# DEVIATION REQUEST AND DECISION FORM

Project Name: Sterling Ranch Sand Creek Channel Construction Drawing Review CDR 20-4
Schedule No.(s): 5227301021, 5233309027, 5228000030 & 38, 5233301001 5233301016 & 17

A deviation from the standards of or in Section ECM section 3.3.3 Open Channel Design Standards of the Engineering Criteria
Manual (ECM) is requested for the Sand Creek Channel Design – Low Flow Channel Capacity.
Identify the specific ECM standard which a deviation is requested:

Exhibit A
Sterling Ranch - Sand Creek Channel - Drop Structures

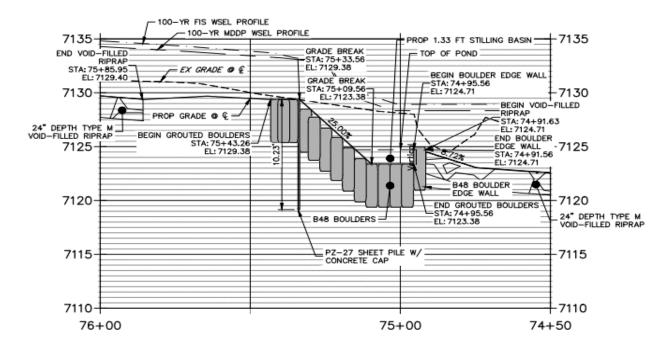
Per ECM Section 3.3.3 Item B. All open channels shall conform to DCM Volume 1 and Volume 2. Per DCM Vol. 1 chapter 6.5 Open Channel Design Criteria, Section 5 Drop Structures, drop structures are to be four feet or less in height.
Open Channel Design Criteria, Section 5 Drop Structures, drop structures are to be four feet or less in height.
State the reason for the requested deviation:
State the reason for the requested deviation:
Drop structures were placed strategically to reduce the amount of disturbance to the existing wetland corridor within the channel.
Drop heights were also determined based upon wetland preservation which required some of the drop structures to exceed the
four foot height criteria.
Tour foot fleight official.
Explain the proposed alternative and compare to the ECM standards (May provide applicable regional or national standards used
as basis):
See Exhibit A for a table of the various drop heights used in the Sand Creek Channel plans along with a representative cross

section of the general design.
In the design there are 9 grouted houlder drop structures. Soven are typically configured with great too stilling begin and sill wall
In the design there are 8 grouted boulder drop structures. Seven are typically configured with crest, toe, stilling basin and sill wall
Land corve to reduce channel longitudinal clone thereby decreasing flow velocities. One drop (CSP #6) is used as a rundown into
and serve to reduce channel longitudinal slope thereby decreasing flow velocities. One drop (GSB #6) is used as a rundown into
existing stock pond #2 in the reach above Briargate Parkway and the toe is below the existing water surface, therefore this drop
existing stock pond #2 in the reach above Briargate Parkway and the toe is below the existing water surface, therefore this drop
existing stock pond #2 in the reach above Briargate Parkway and the toe is below the existing water surface, therefore this drop

LIMITS OF CONSIDERATION (At least one of the conditions listed below must be met for this deviation request to be considered.)
<ul> <li>□ The ECM standard is inapplicable to the particular situation.</li> <li>□ Topography, right-of-way, or other geographical conditions or impediments impose an undue hardship and an equivalent alternative that can accomplish the same design objective is available and does not compromise public safety or accessibility.</li> <li>☑ A change to a standard is required to address a specific design or construction problem, and if not modified, the standard will impose an undue hardship on the applicant with little or no material benefit to the public.</li> </ul>
Provide justification:  Drop heights were sized to promote existing wetland preservation. Drop heights in this design are 6 feet or less when measured
from crest to toe and 4.7 feet when measured from crest to sill wall of the stilling basin.

The ECM does allow for drop structure heights above four feet if supported by geotechnical investigations and appropriate measures are incorporated into the drop structure design to relieve hydrostatic groundwater pressure on the drop. Each of the 8 drop structures will have a sheet pile integrated into the crest of drop structure and will have a weep hole system to relieve hydrostatic groundwater pressure even regardless of height.
CRITERIA FOR APPROVAL
Per ECM section 5.8.7 the request for a deviation may be considered if the request is <b>not based exclusively on financial considerations</b> . The deviation must not be detrimental to public safety or surrounding property. The applicant must include supporting information demonstrating compliance with <b>all of the following criteria</b> :
The deviation will achieve the intended result with a comparable or superior design and quality of improvement.  This request is not based on financial considerations. The primary reason for the exceeding the four foot drop height criteria was to lessen disturbance to the existing wetland corridor.
